Case No. P/8 209/34

With reference to your application dated ~~22/3~~ 19-4-34
with a plan for the proposed building/additions and alterations on plot
No. 31/3, Survey Sheet No. J. V. 3, Jamshed Quarter
I have to request you to comply with the following requirements:—

PROPOSED BUNGALOW ON PLOT No.37/3. J.M. 3

HYDERABAD AMIL CO-OPERATIVE HOUSING SOCIETY.

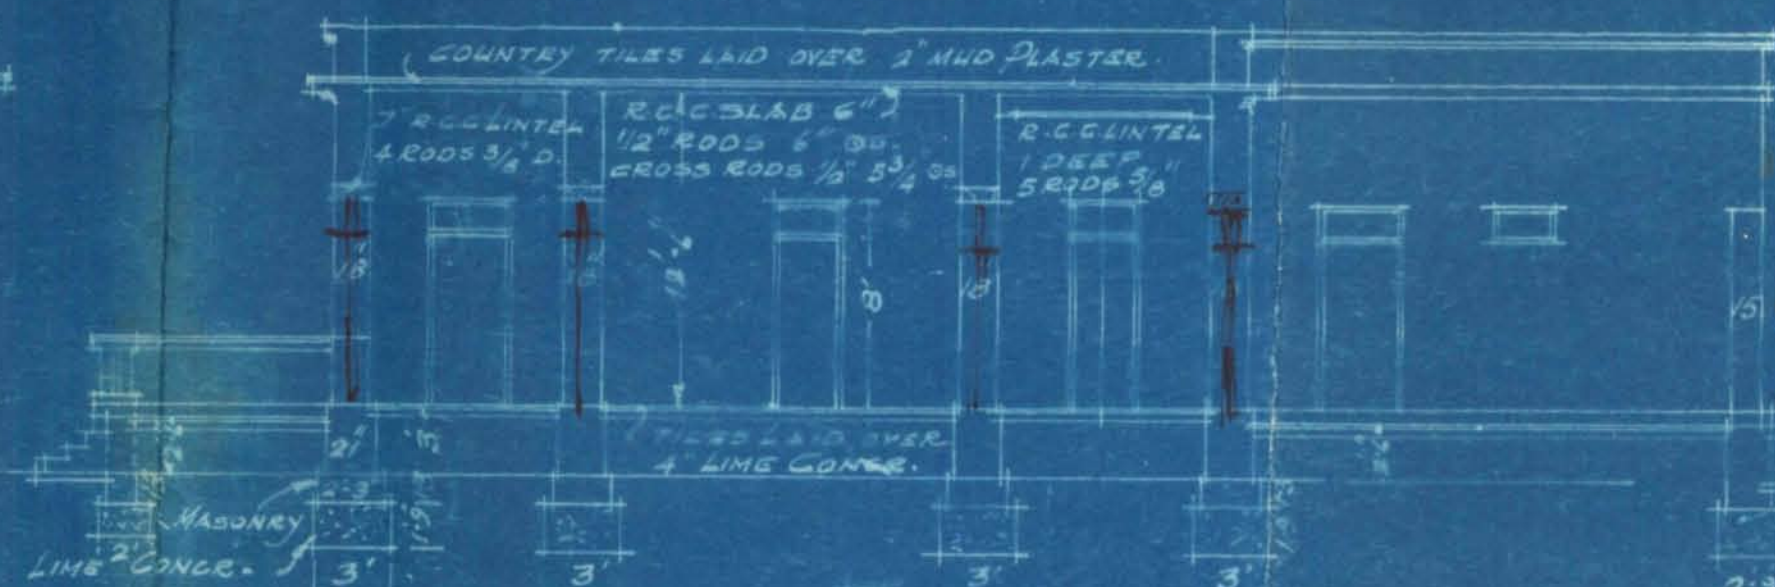
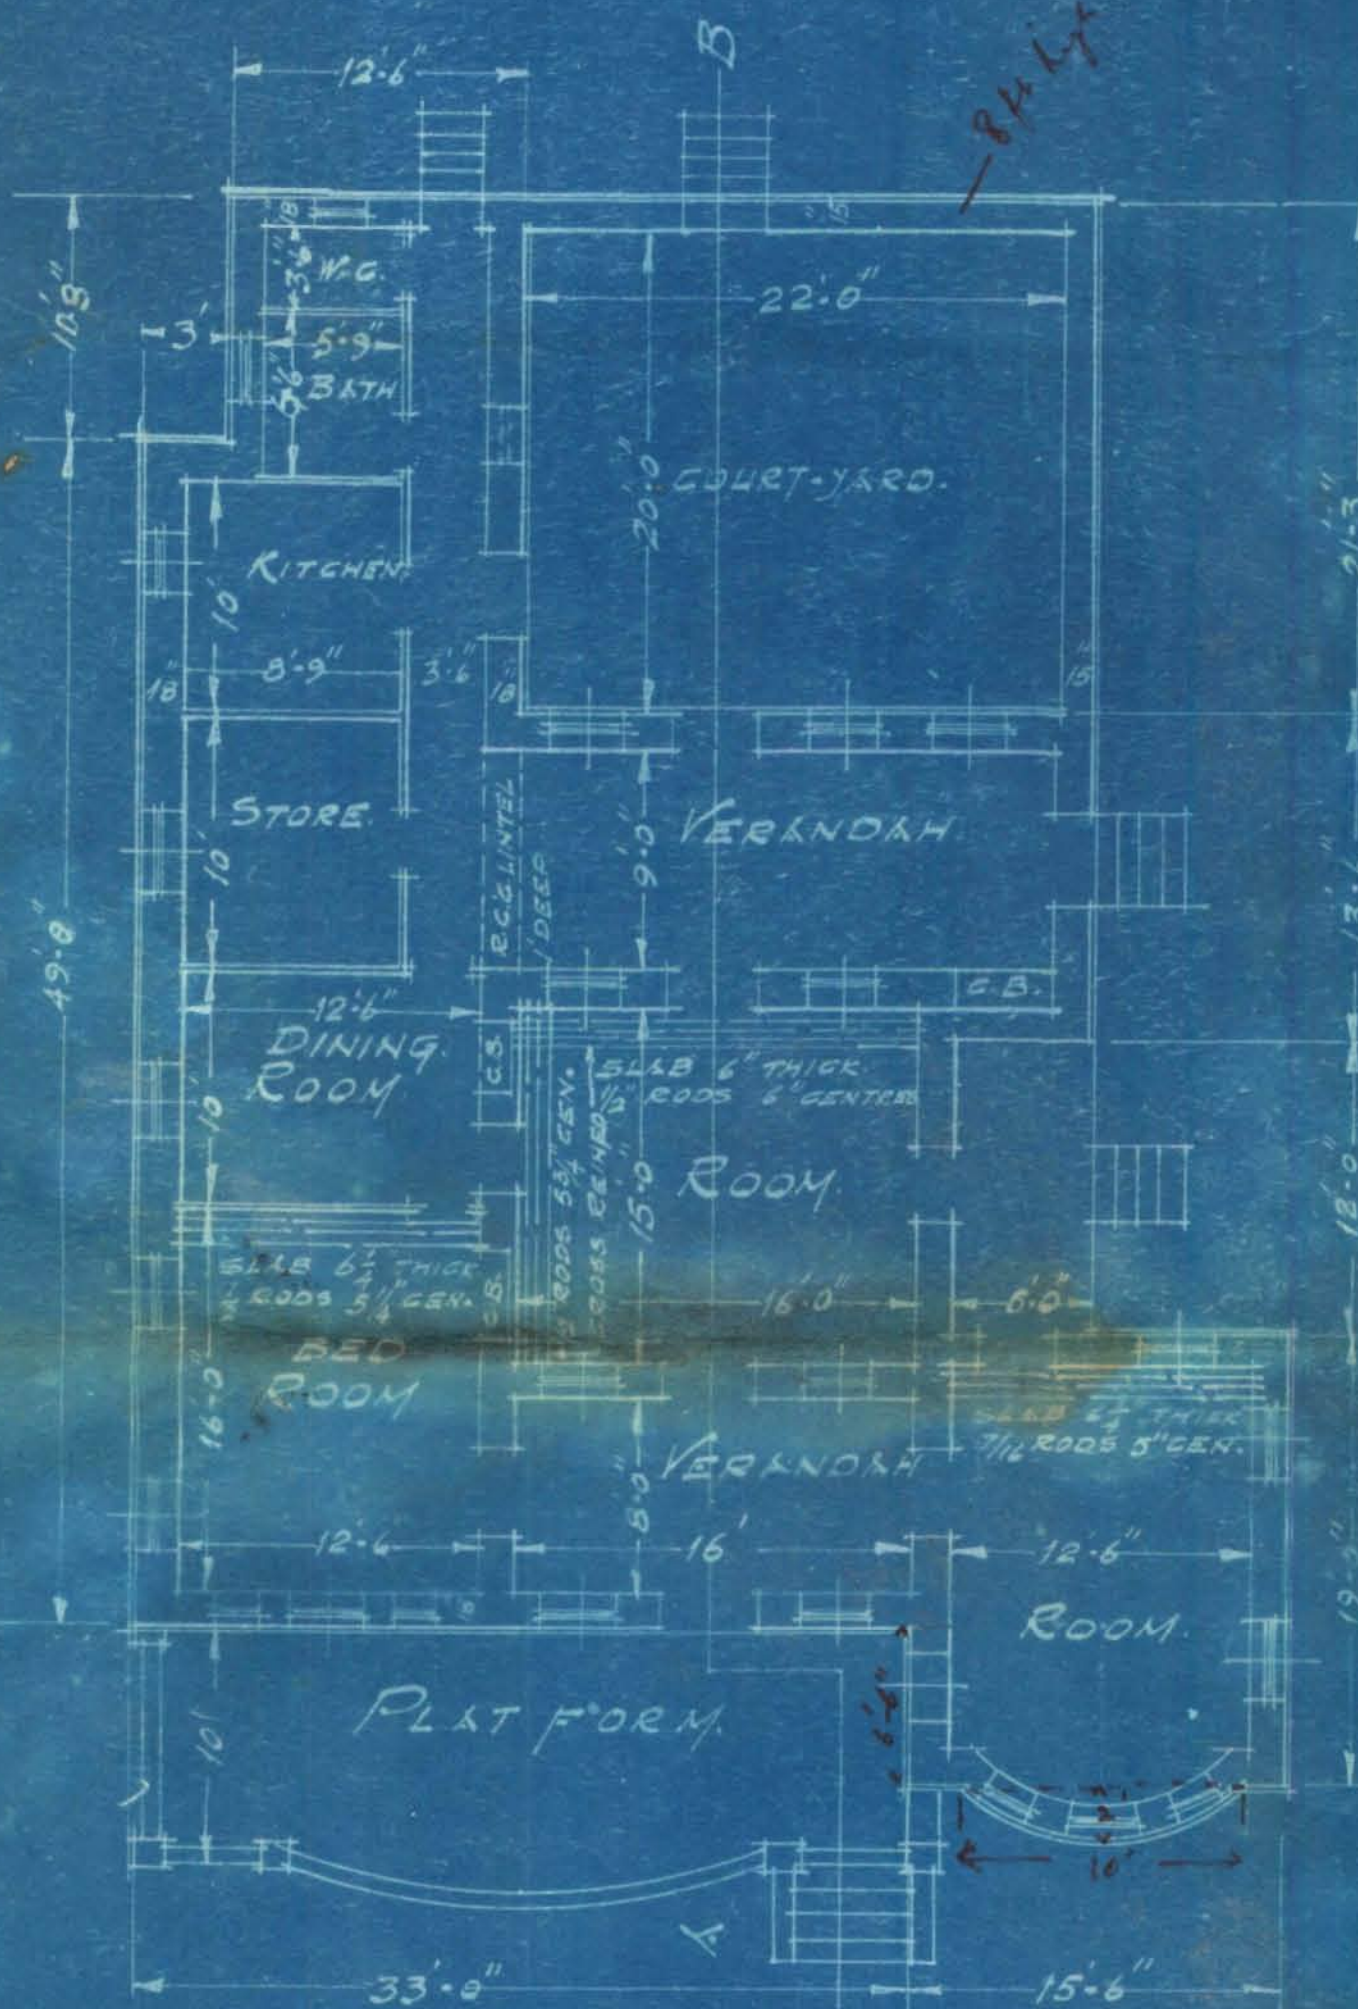
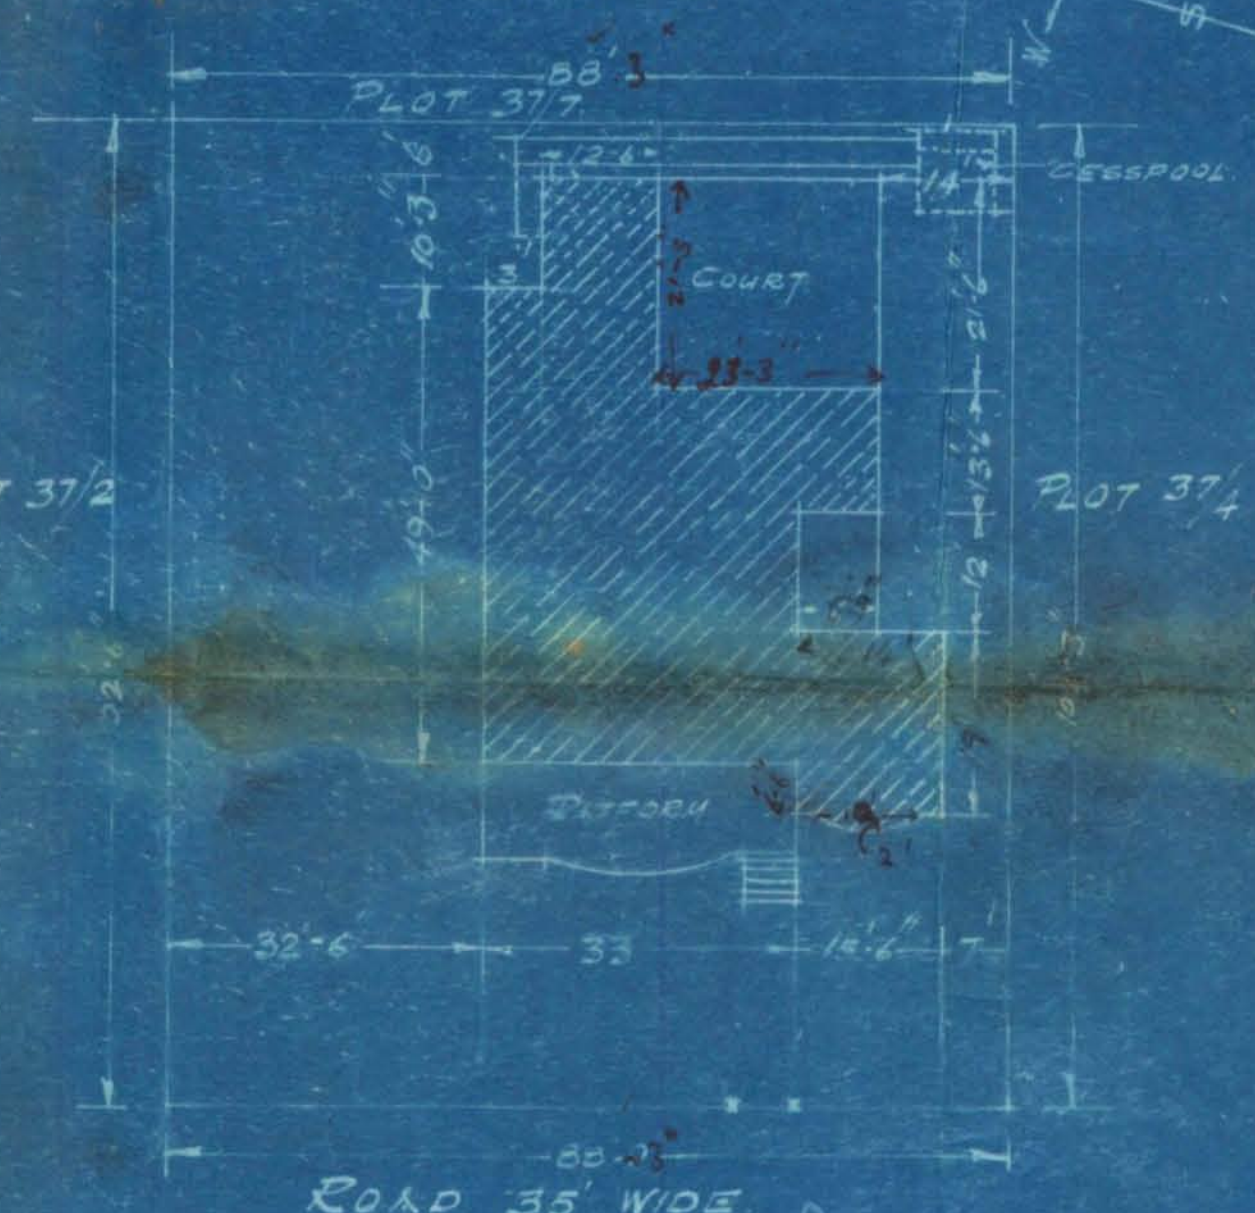
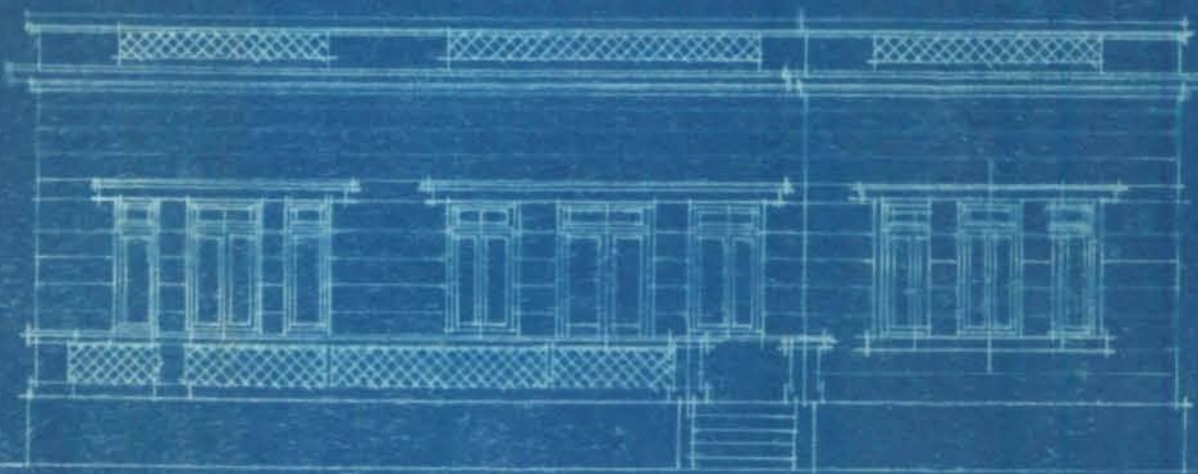
n.s. cannot be permitted as there is no drainage land in this area.

1. W. cs. cannot be permitted as there is no drainage
line in this area.

The plans are returned herewith rejected.

As there is no drainage in this area, there is no objection to allow privies with cess pits.

With reference to your letter No.B.S.R. 20/34
dated 19-4-1934, I enclose herewith the plan duly amended
showing therein Privy instead of W.Cs.

PROPOSED BUNGALOW ON PLOT No.37/3. J.M. 3

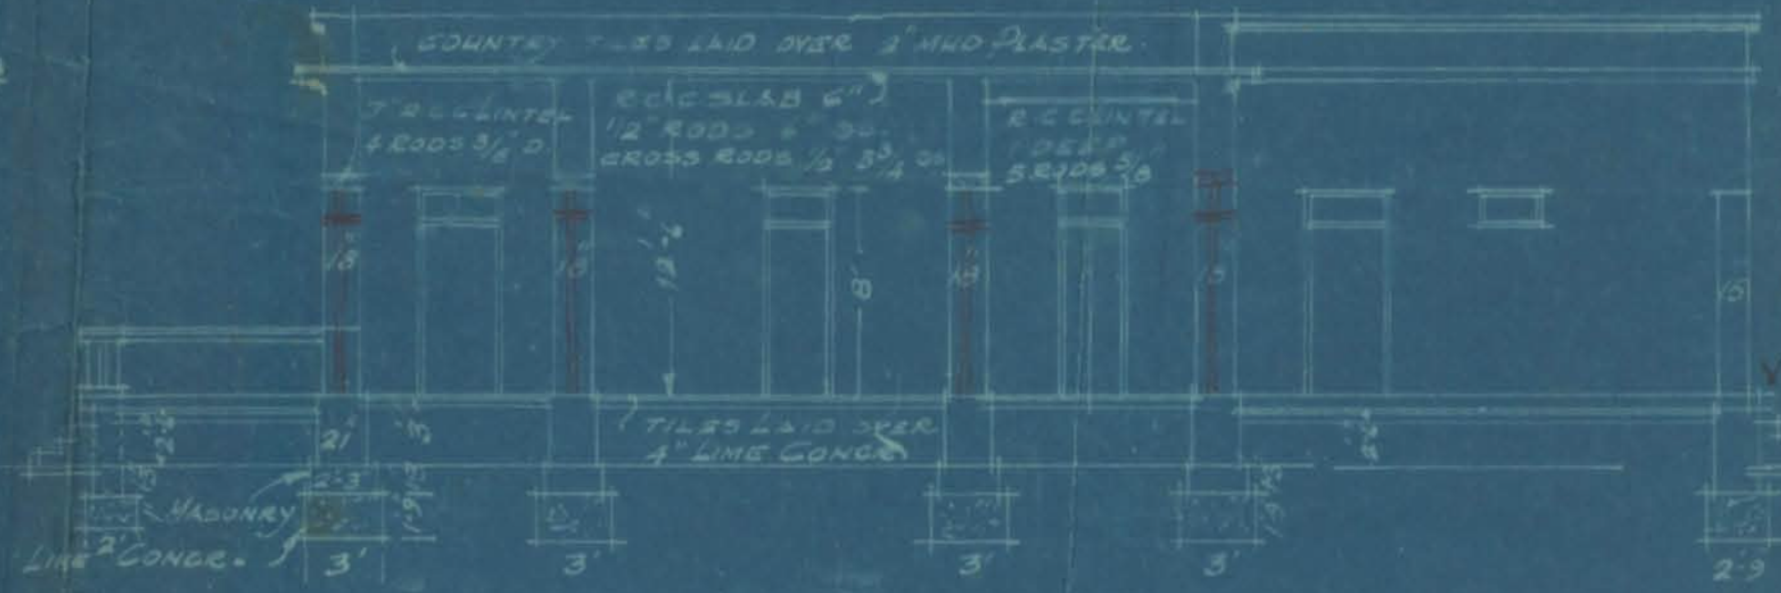
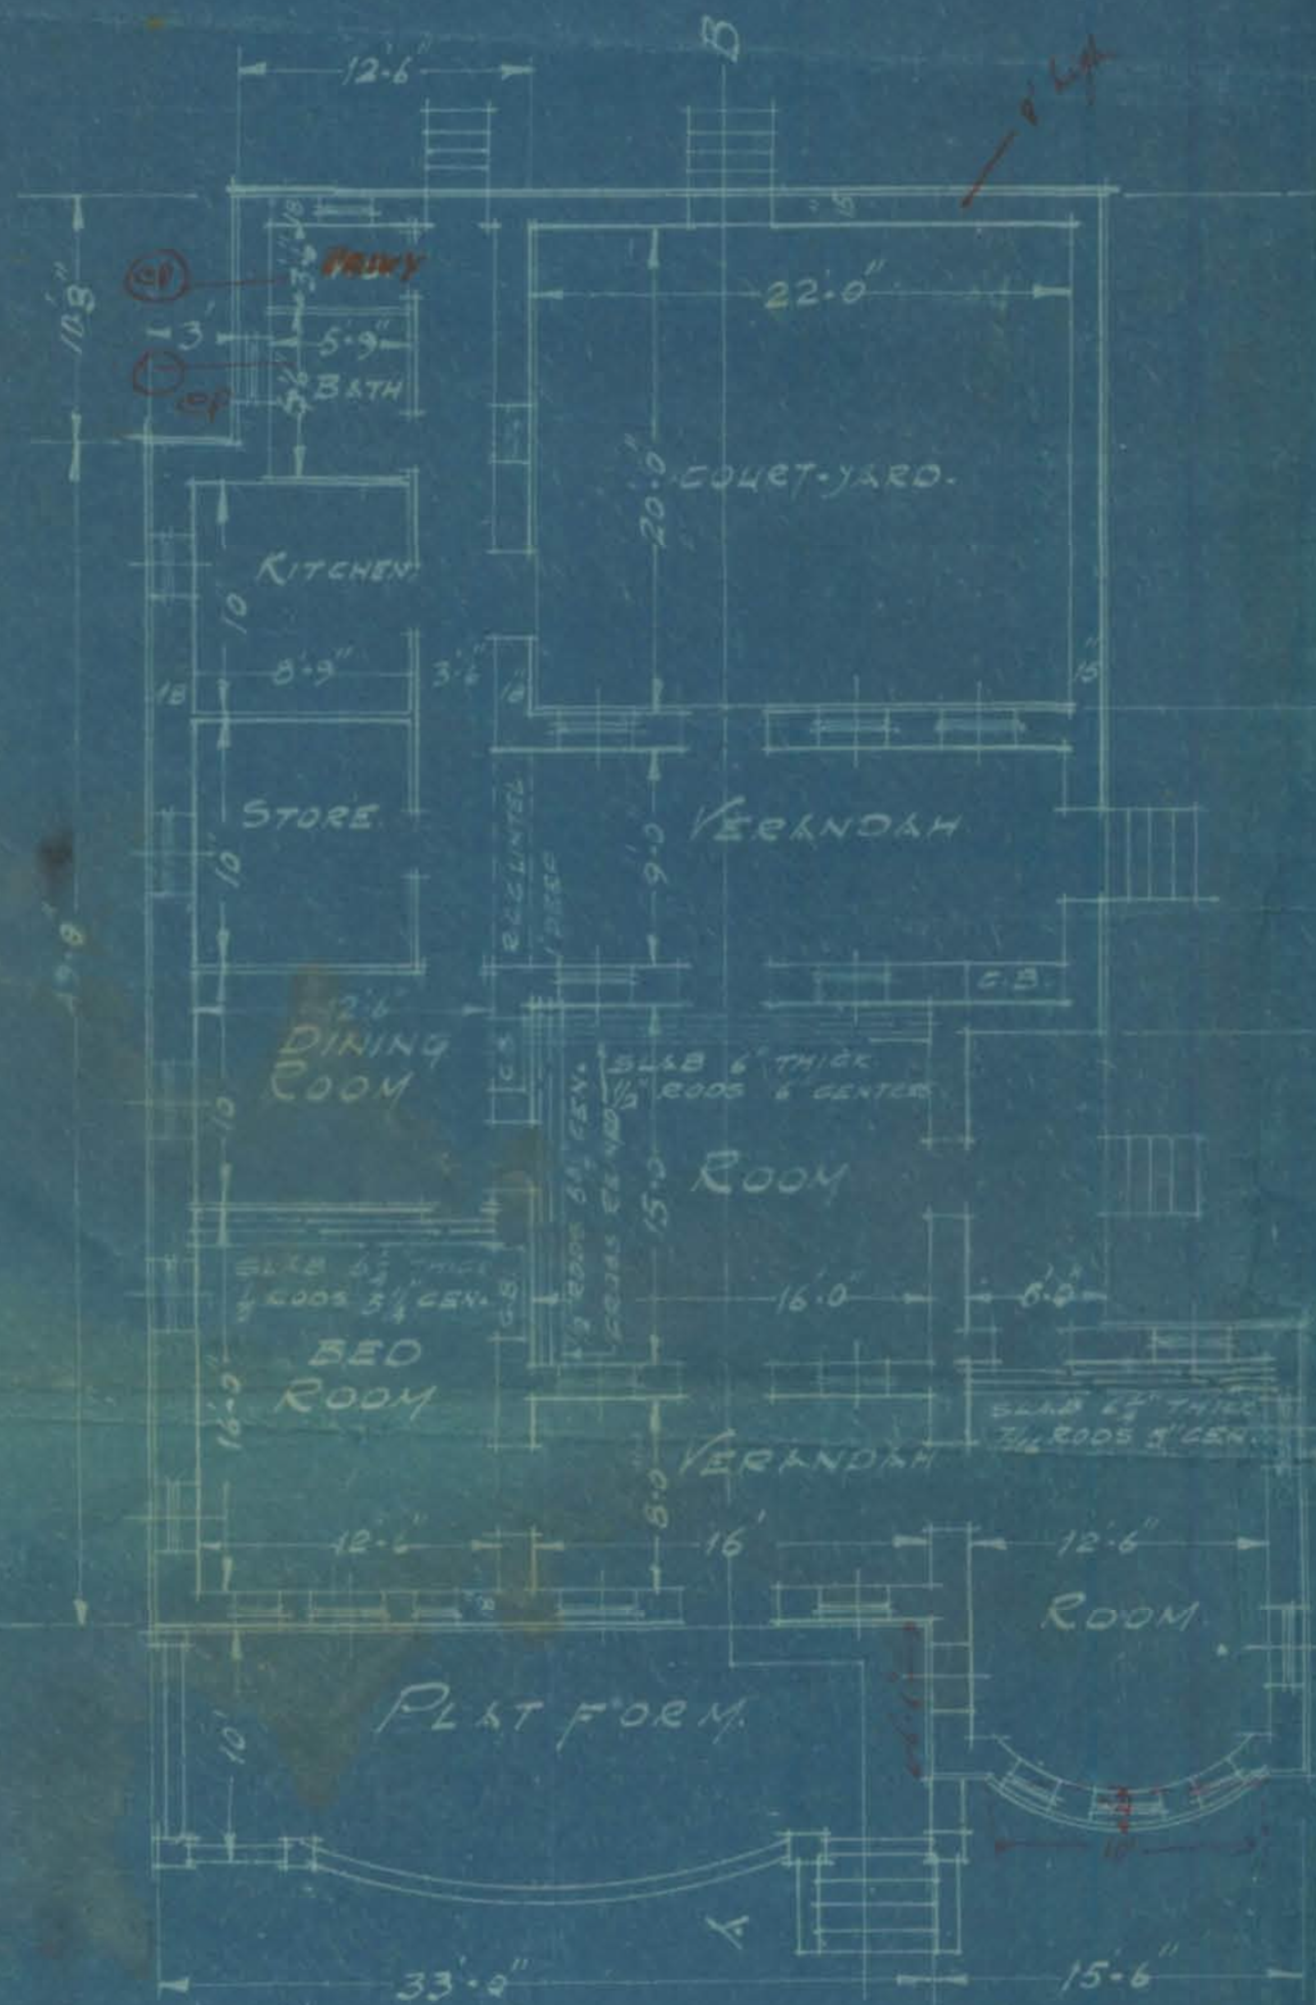
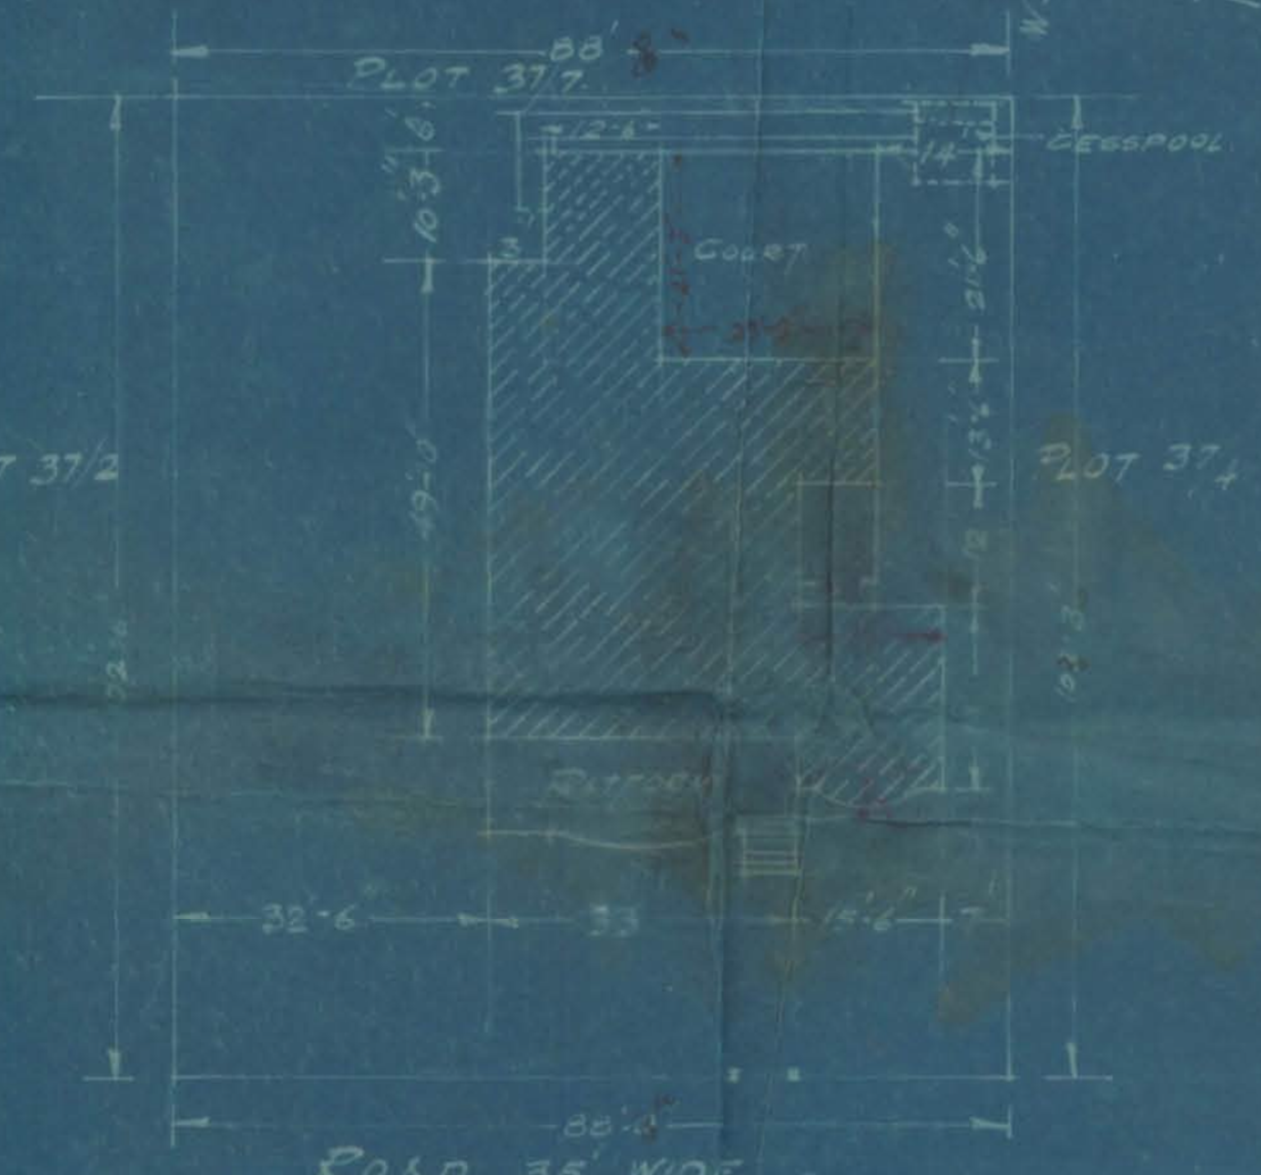
you are requested to kindly call at the Municipal Office on any
 week day except Saturday from 3.30 p.m. to 4.30 p.m. ^{and see the building surveyor} when the
 the requirements of this office will be pointed out to you. *The copies of the plan*
require to be corrected.

Submitted the architect has
complied the H.O's requirement
The plan may please be approved
